METROPOLITAN GOVERNMENT OF NASHVILLE AND DAVIDSON COUNTY

STAFF RECOMMENDATION
1005 Seymour Avenue
April 18, 2012

Application: Infill
District: Greenwood Neighborhood Conservation Zoning Overlay
Council District: 05
Map and Parcel Number: 08305000200
Applicant: Peggy Newman
Project Lead: Melissa Baldock, melissa.baldock@nashville.gov

<p>Description of Project: Construct a new single-family house on a vacant lot.</p> <p>Recommendation Summary: Staff recommends approval of the project with the following conditions:</p> <ol style="list-style-type: none"> 1. The front and rear porch columns have a cap and a base. 2. Staff review and approve the asphalt shingle color, porch and step material, and the window and door materials and specifications prior to purchase and installation. 3. The driveway be concrete strips to at least the front wall of the house. 4. A central pathway from the sidewalk to the front porch be added. 5. Any utilities be located in the rear of the house or on a side façade beyond the midpoint of the house. 6. Staff review and approve any new appurtenances, including, but not limited to, additional pathways, paving, lighting fixtures, and fences, prior to the purcha

**1005 SEYMOUR RD
SITE PLAN**

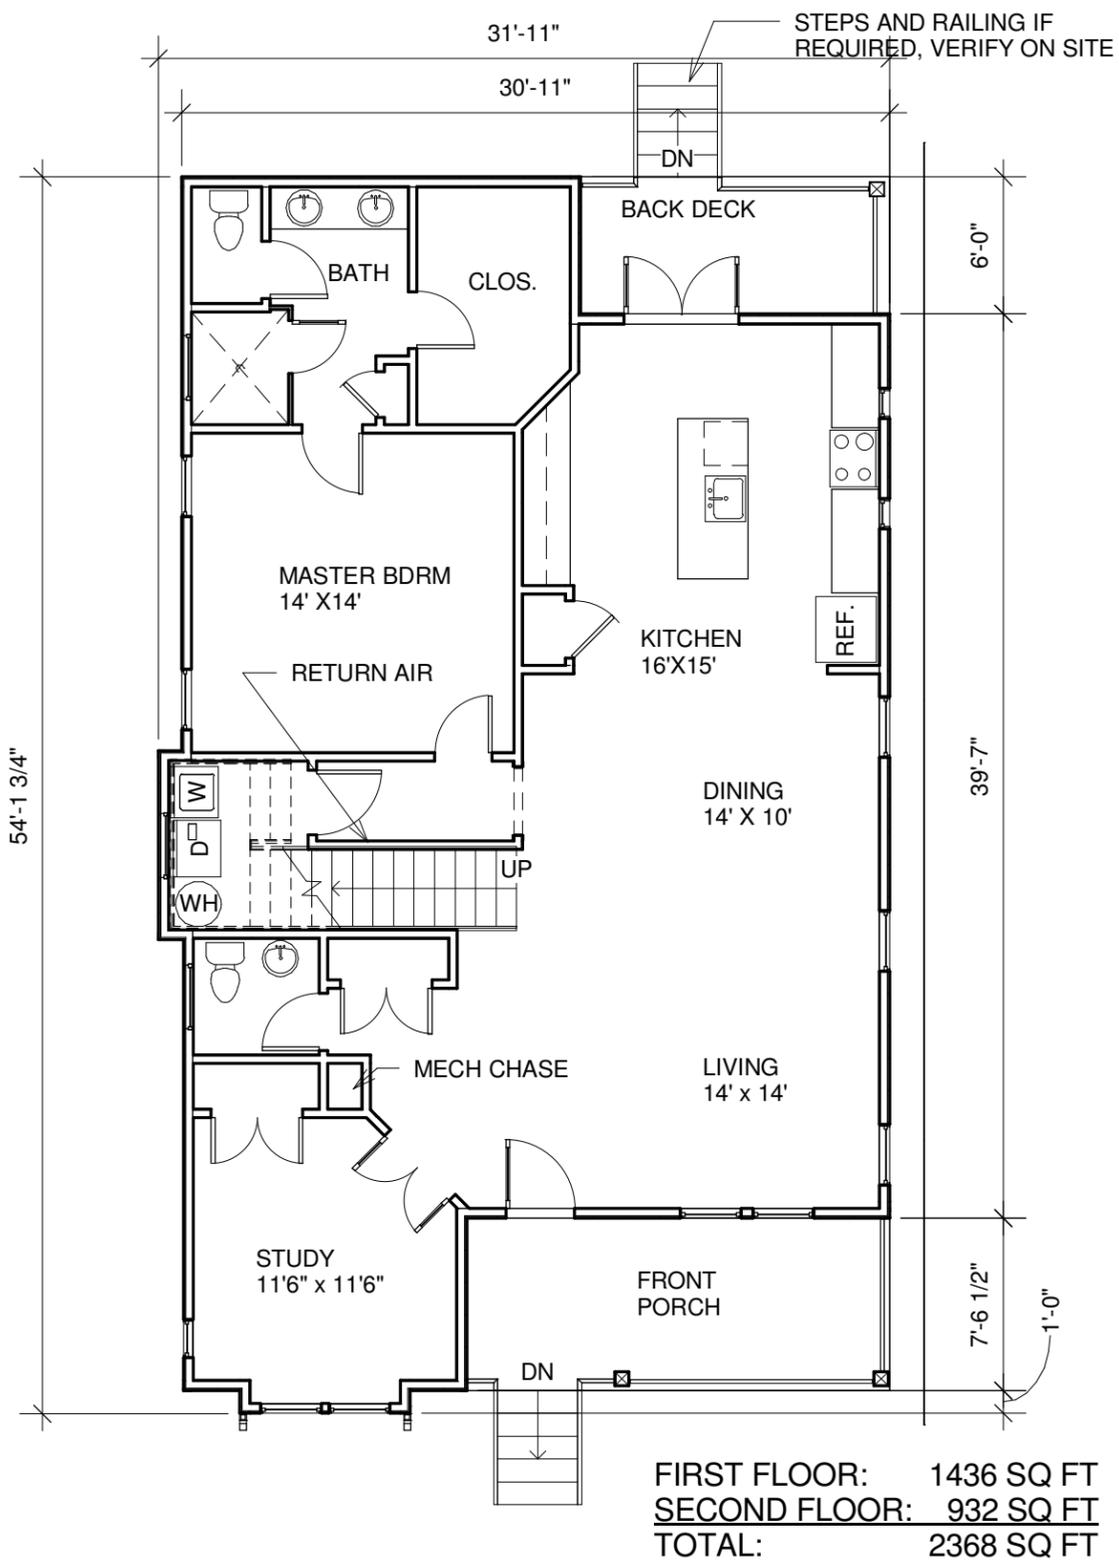
Public Spaces & Utilities: There is an existing curb cut and the remnants of a gravel driveway on the right side of the lot. The application involves creating a new driveway that will extend from the curb to the back corner of the house. Because there is no existing hardscape driveway, staff asks that the new driveway be concrete strips to at least the front wall of the house.

A walkway from the driveway to the front of the house is planned. Staff asks that a pathway from the sidewalk to the front porch also be added to the site. The location of the HVAC system is unknown at this time. Staff recommends that it be located at the rear of the home or on the side, beyond the mid-point of the house. No other appurtenances were indicated on the plans, and staff asks that a condition of approval be that staff review and approve any new appurtenances, including, but not limited to, additional pathways, paving, lighting fixtures, and fences, prior to the purchase and installation of these materials.

1. The front and rear porch columns have a cap and a base.
2. Staff review and approve the asphalt shingle color, porch and step material, and the window and door materials and specifications prior to purchase and installation.
3. The driveway be concrete strips to at least the front wall of the house.
4. A central pathway from the sidewalk to the front porch be added.
5. Any utilities be located in the rear of the house or on a side façade beyond the midpoint of the house.
6. Staff review and approve any new appurtenances, including, but not limited to, additional pathways, paving, lighting fixtures, and fences, prior to the purchase and installation of these materials.

1005 SEYMOUR RD FRONT ELEVATION 1/8" = 1'-0"

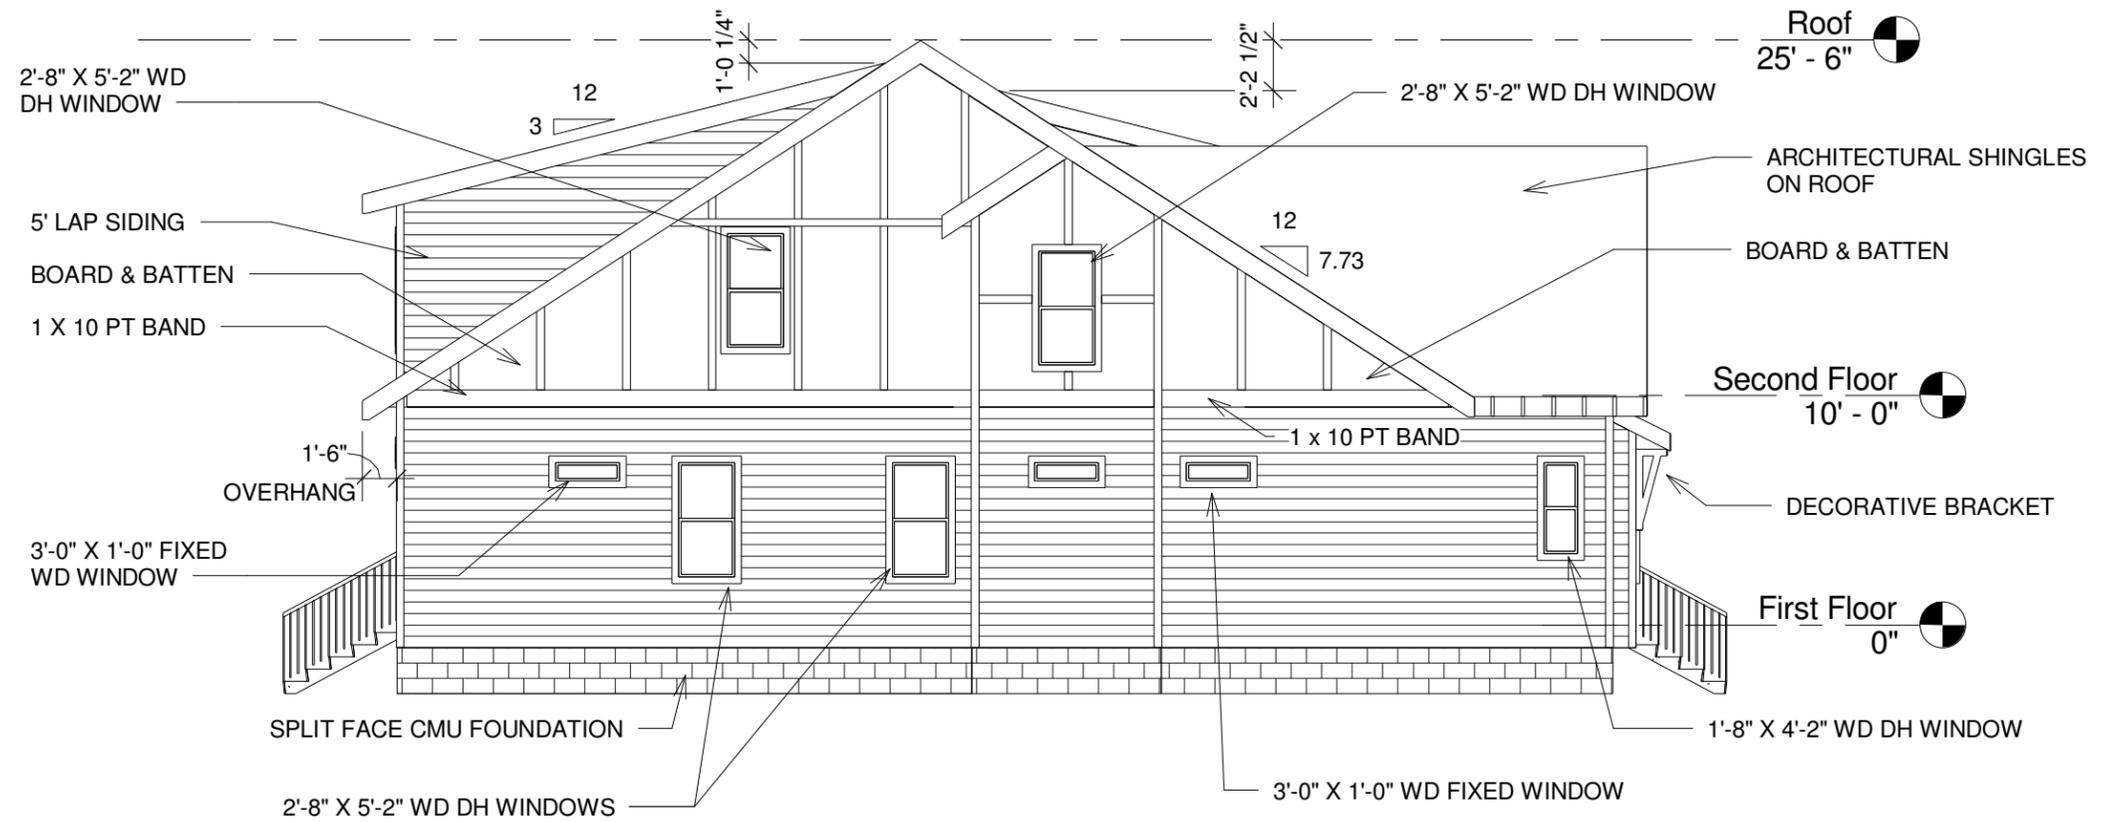
Staff finds the proposed height of the new construction to be appropriate for several reasons. The side-gable main form of the house helps to minimize its height, as the maximum height of twenty-eight feet, six inches (28'6") is not reached until thirty feet (30') behind the front wall of the house. The most forward-portion of the house is a projecting cross gable that is approximately twenty-four-feet (24') tall. Staff also finds that the height matches the historic context because it is several feet lower than other existing historic houses on Seymour Street.

Roof: The primary roof form is a cross gable, and the front and side gables will have a roof slope of 12/12. The front and rear dormers will have a shed roof with a slope of 3/12. The front bay window will have a shed roof with a slope of 6/12, and the front porch roof will have a slope of approximately 3/12. The roof shapes and pitches are found on historic buildings throughout the district and so meet Section II.B.1.e. of the *Greenwood Neighborhood Conservation Zoning Overlay Handbook and Design Guidelines*.

Orientation: The proposed structure has an asymmetrical façade with a centered front entrance. Its porch is located on the right portion of the front façade. The house is oriented to face Seymour Avenue, as are all of the buildings on this block. Staff finds
